SUBJECT Sewer Service Associated with
Request for Lot Split of Lot 1,
Block 4, Second Addition to
Cedar Ridge, Wichita, Kansas
(L/S-0659)

Re: S/D 80-28 - Final plat of Second Addition to Cedar Ridge
(formerly named 6th Addition to Cherry Creek Hills)

Re: S/D 80-28 - Preliminary plat of 6th Addition to Cherry
Creek Hills

SUBDIVISION REPORT

ADDITION TO CEDAR RIDGE

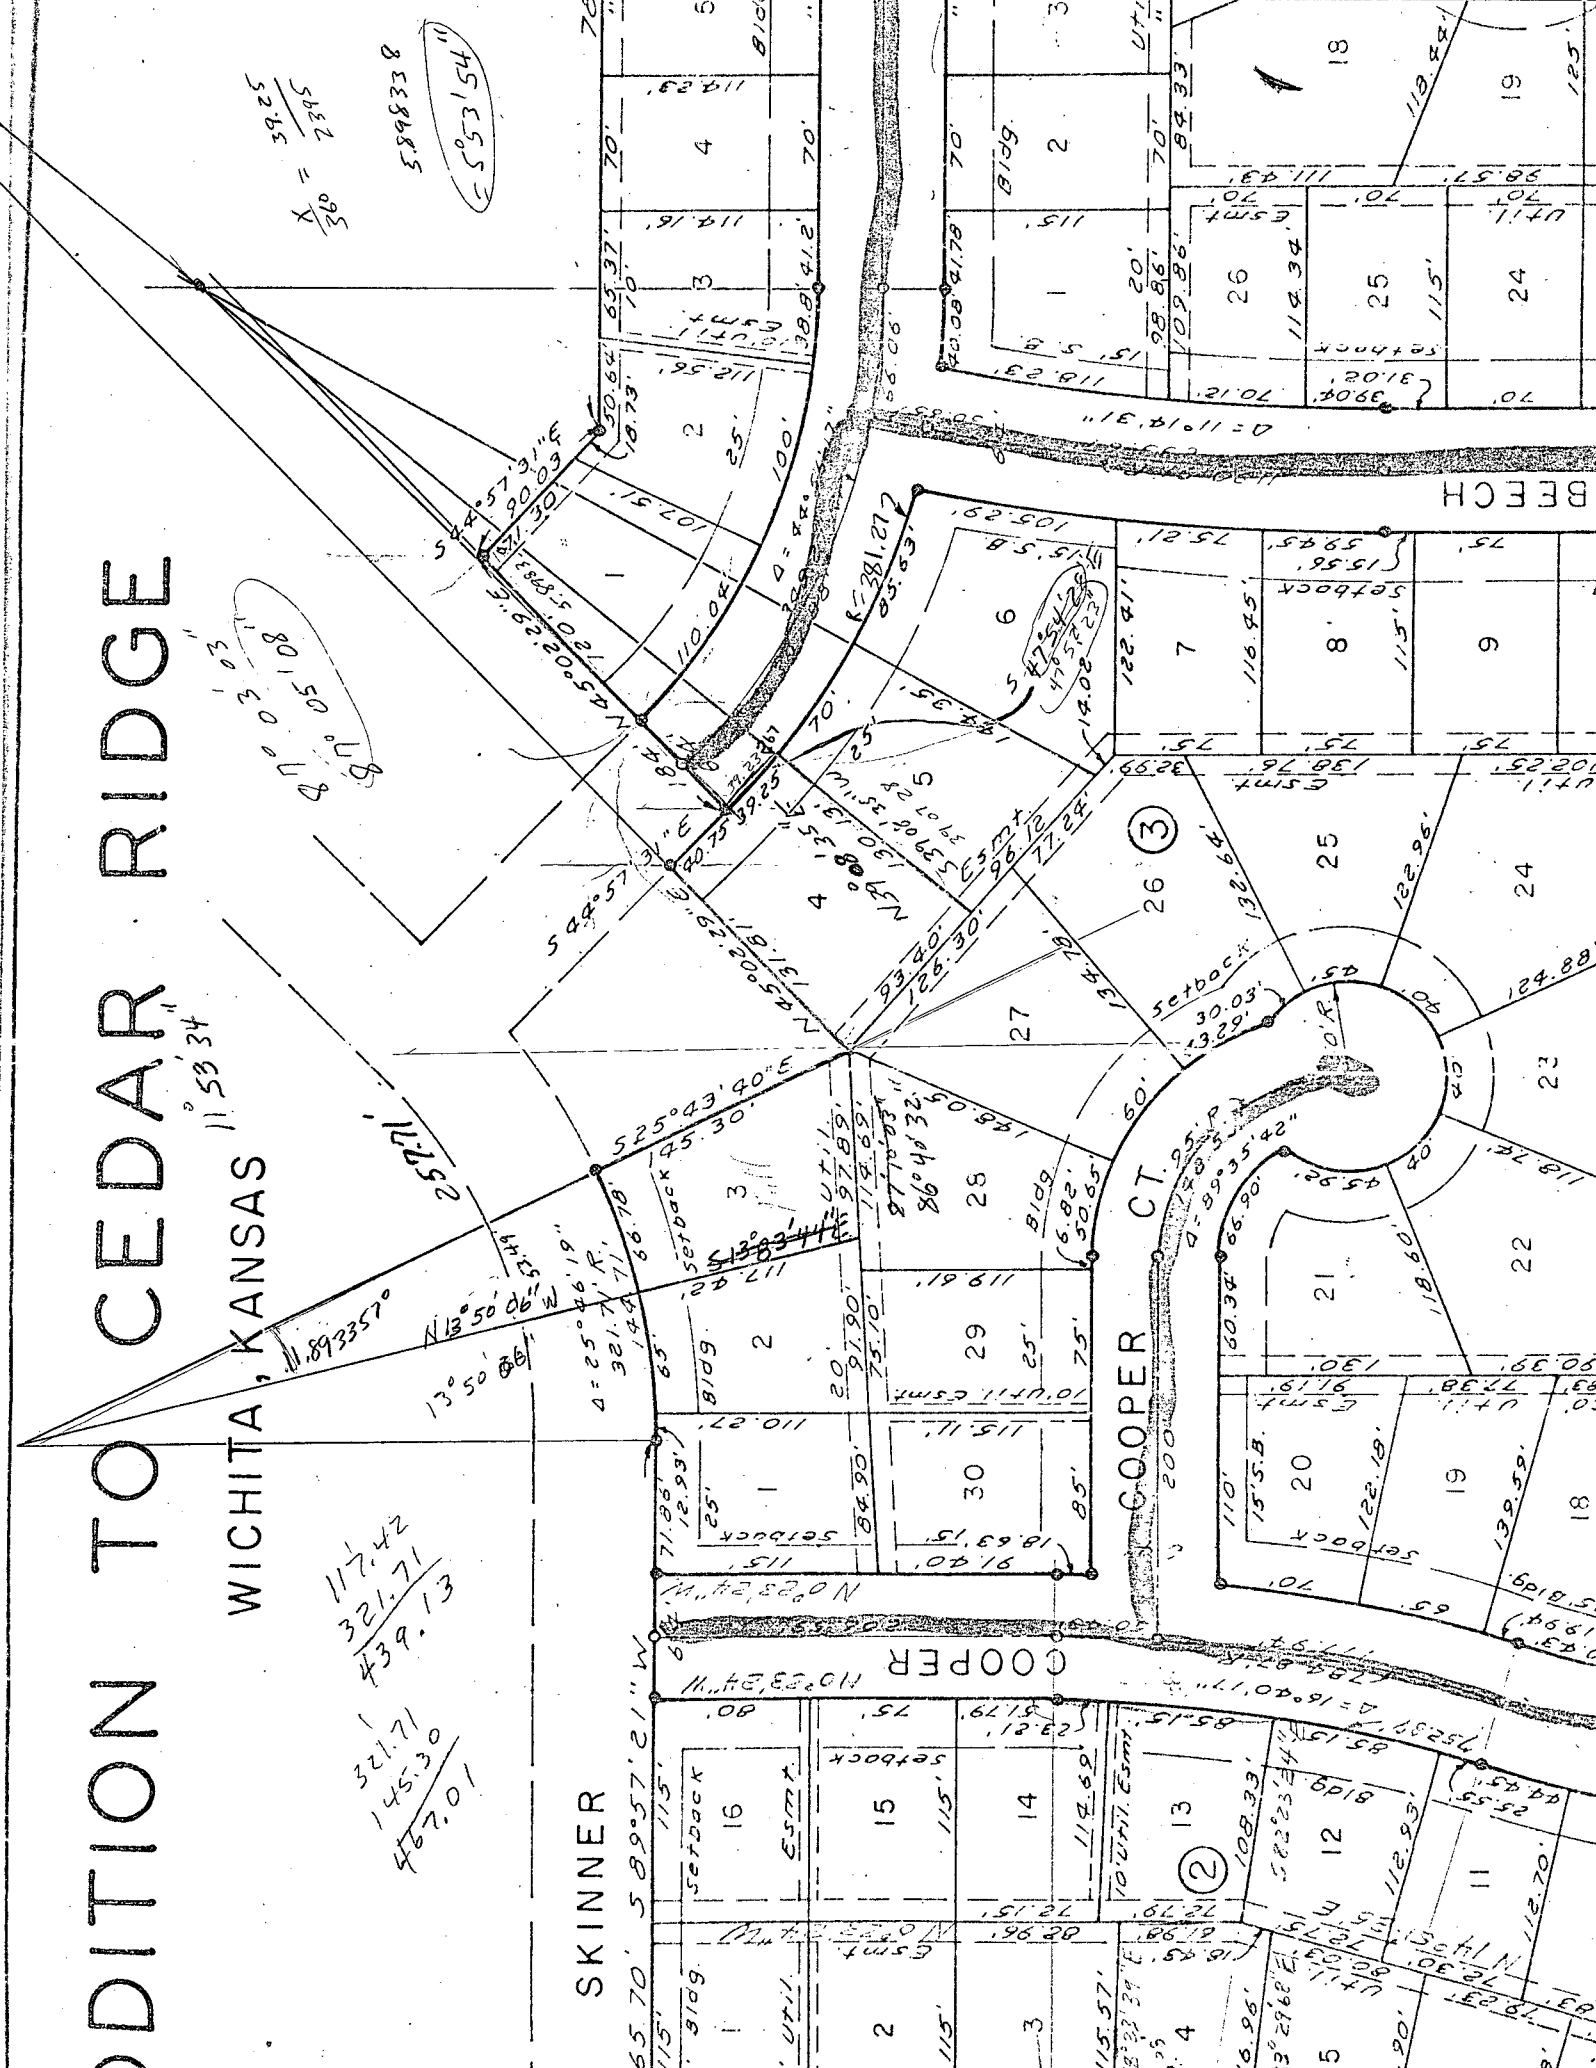
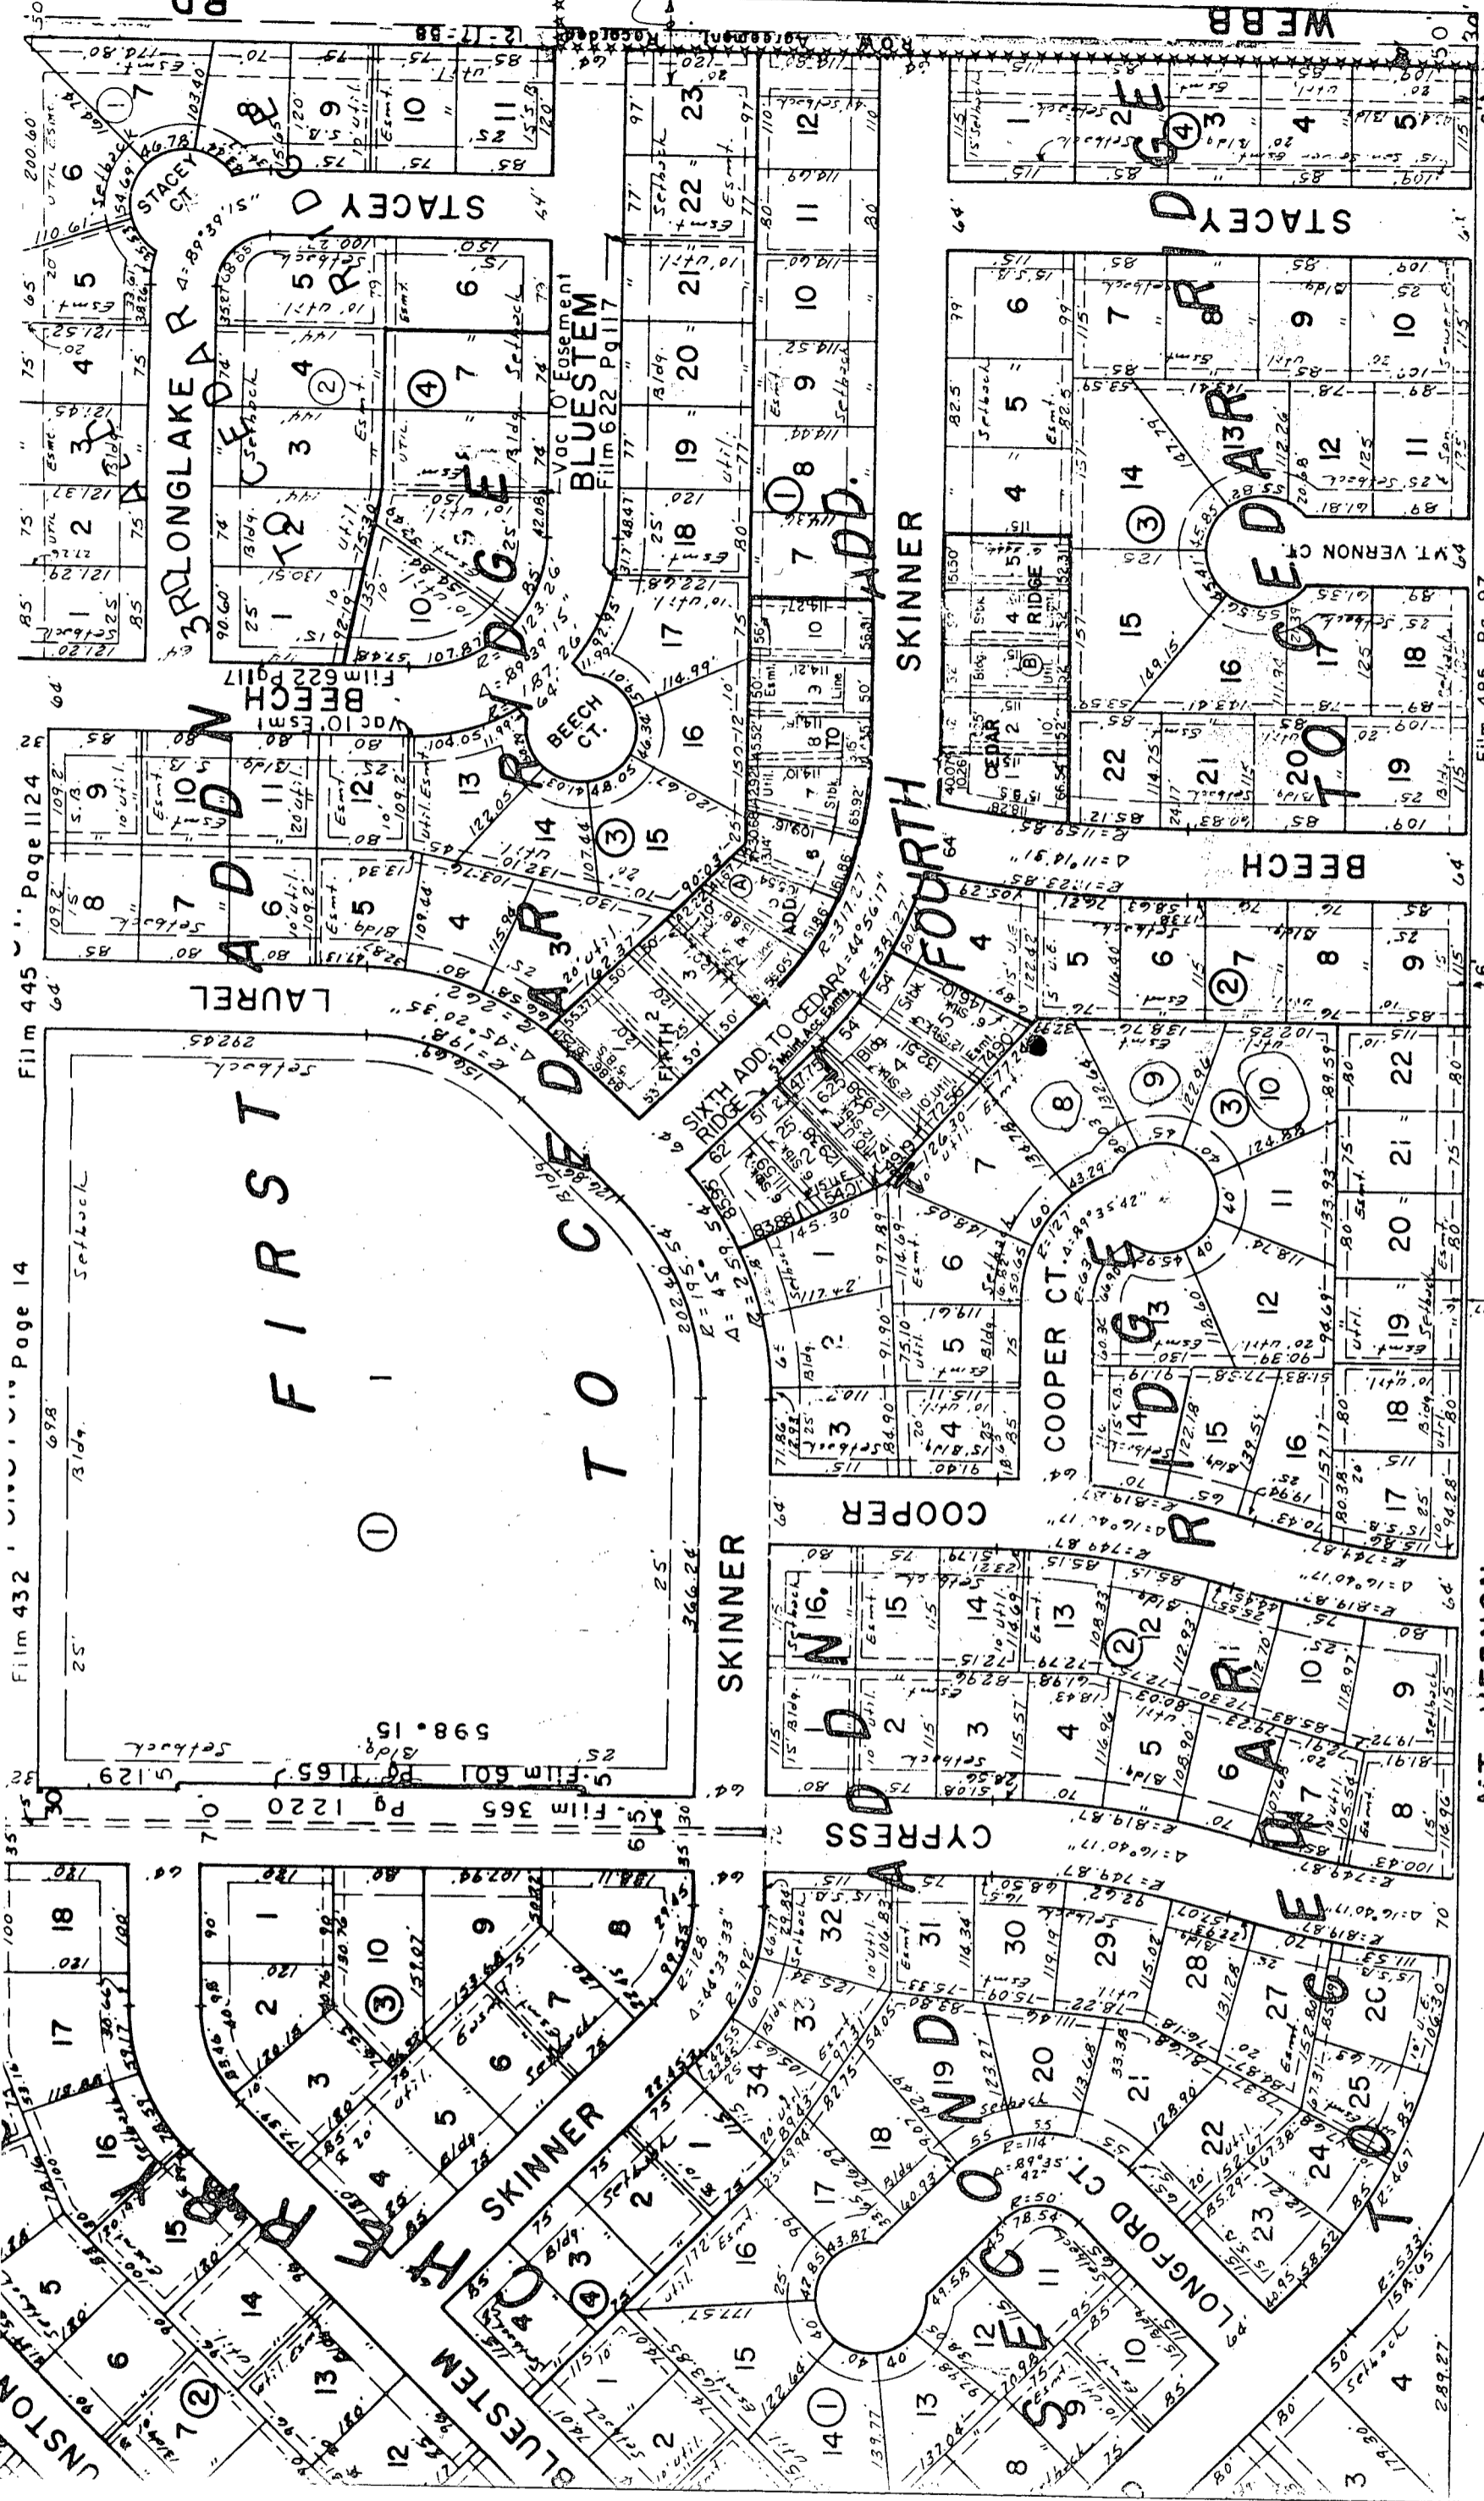
2 YR. COMPLAINT
WATER PONDING IN ST.
ENG. NOT ACCEPTING RESP.

400' S. OF HIM.
REAR LOT EASEMENT
